ORIGINATION FORM

Proposed Revisions to a Standard Plans Index (Please provide all information — Incomplete forms will be returned)

Index Number: 665-001
Sheet Number (s): 1
Index Title: Pedestrian Detector Assembly Installation
Details

PEDESTRIAN DETECTOR ASSEMBLY
INSTALLATION DETAILS

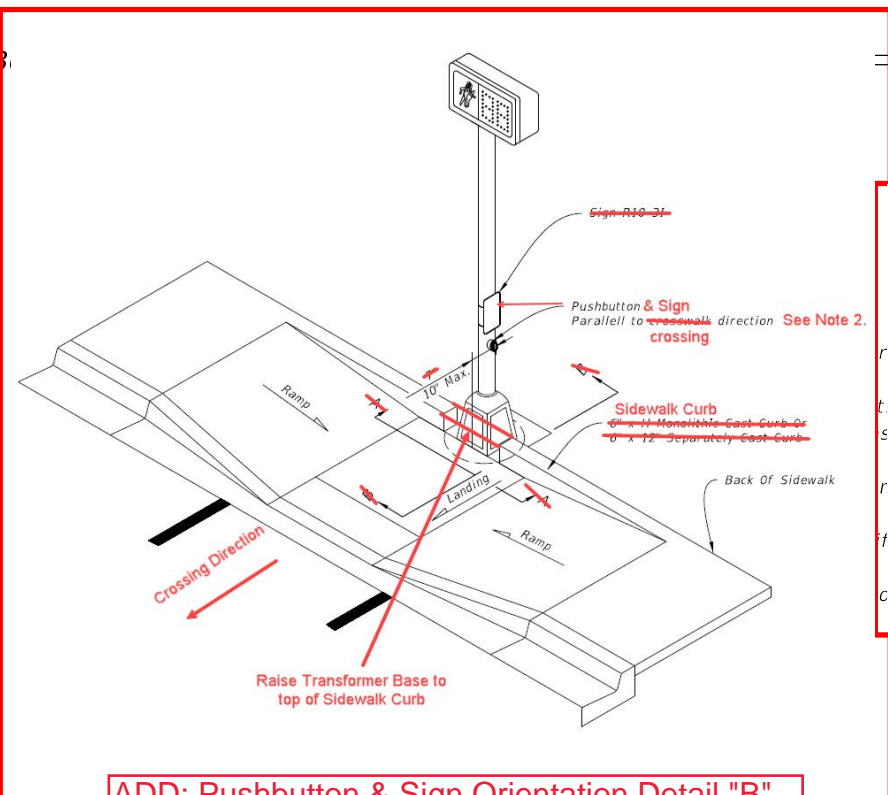
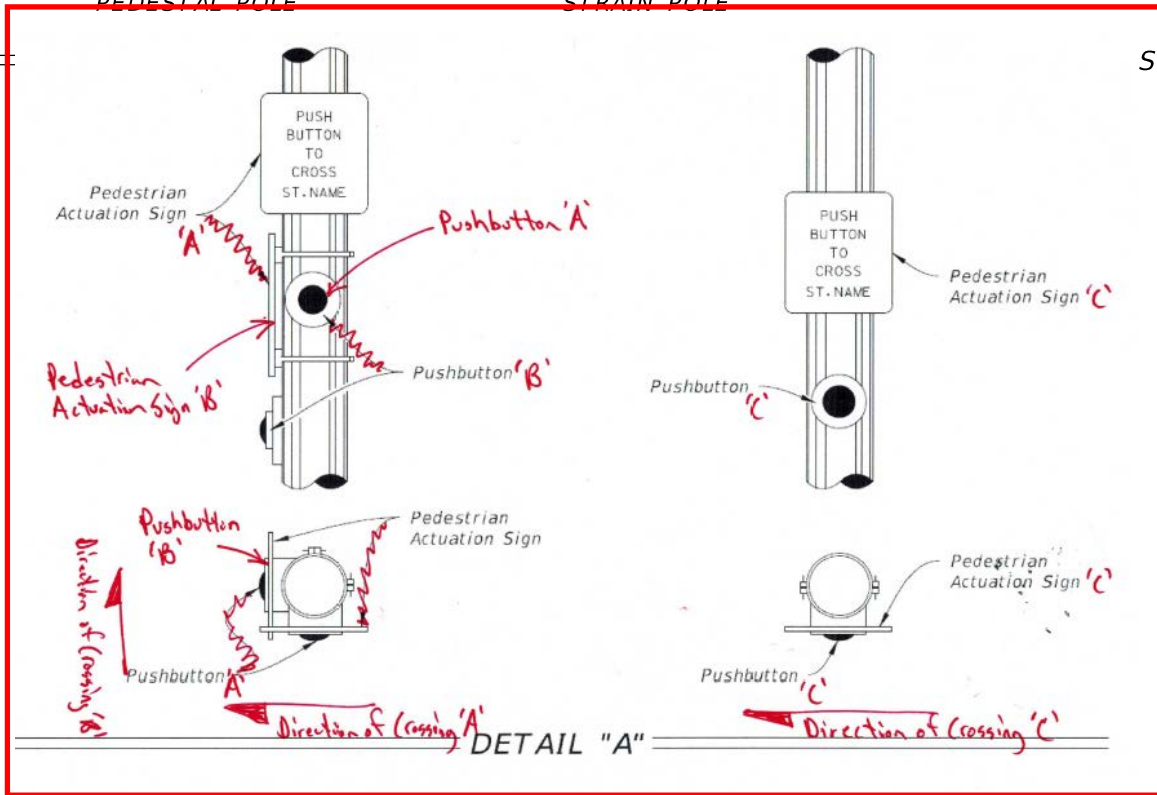
~~GALVANIZED POLE~~

~~ALUMINUM POLE~~

~~PEDESTAL~~

- NOTES:**
1. Mount Signs above the detectors. See Index 700-102 for sign details.
 2. Install Pushbuttons and Pedestrian Actuation Signs with faces parallel to the crossing direction, ~~or as shown in the Plans. See Detail "B".~~
 3. Mount pushbuttons and Signs in accordance with Specification 665.
 4. ~~Install all grounding per Specification 620.~~
 5. Pushbutton mounting height shown ~~above~~ is taken at the center of the actuation switch.
 6. For Pedestrian Control Signal see Index 653-001
 7. For Aluminum Pole and Pedestal supports see Index 646-001

ALUMINUM POLE

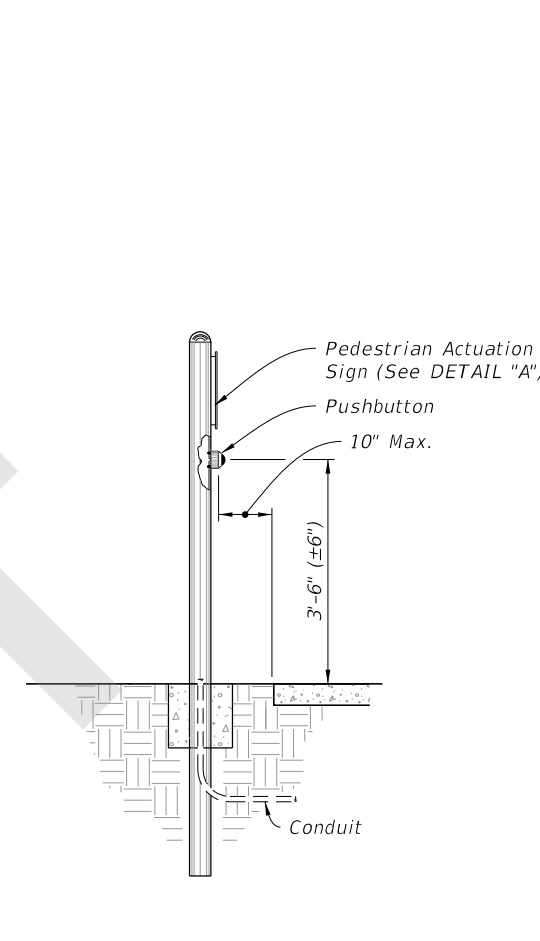
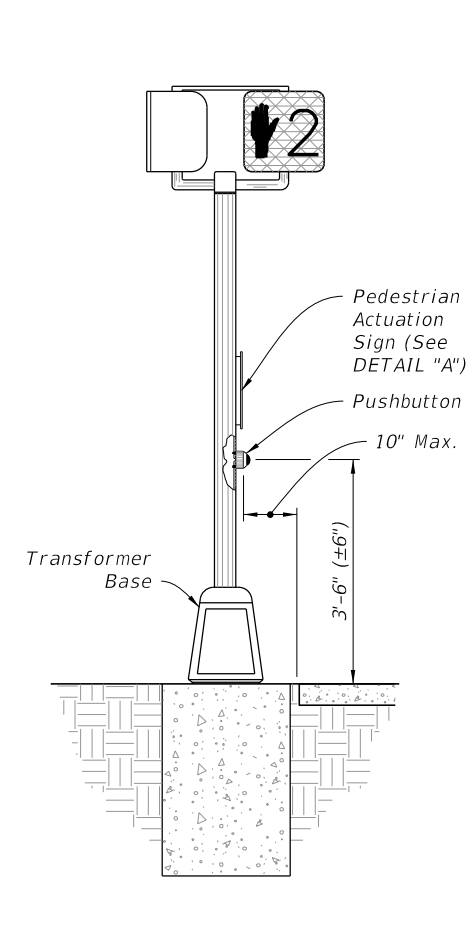
Deleted information specific to the Aluminum Pole and Pedestal supports. These details will be included in a New Standard Plans, Index 646-001. A Pushbutton Orientation (New Detail "B") has been added to clarify Note 2. Added further clarification of pushbutton and sign orientation to Detail "A". Deleted "Galvanized Pole" option, as it is not covered by Standard Specifications for Pay Items.

There has been confusion about the foundation requirements and payment for Aluminum Pole and Pedestal supports for pedestrian signal and detectors. Relocating this information to a NEW Index 646 will clarify the intent, as installation and payment information is covered by Specification 646. See Also: Revision to Index 653-001.
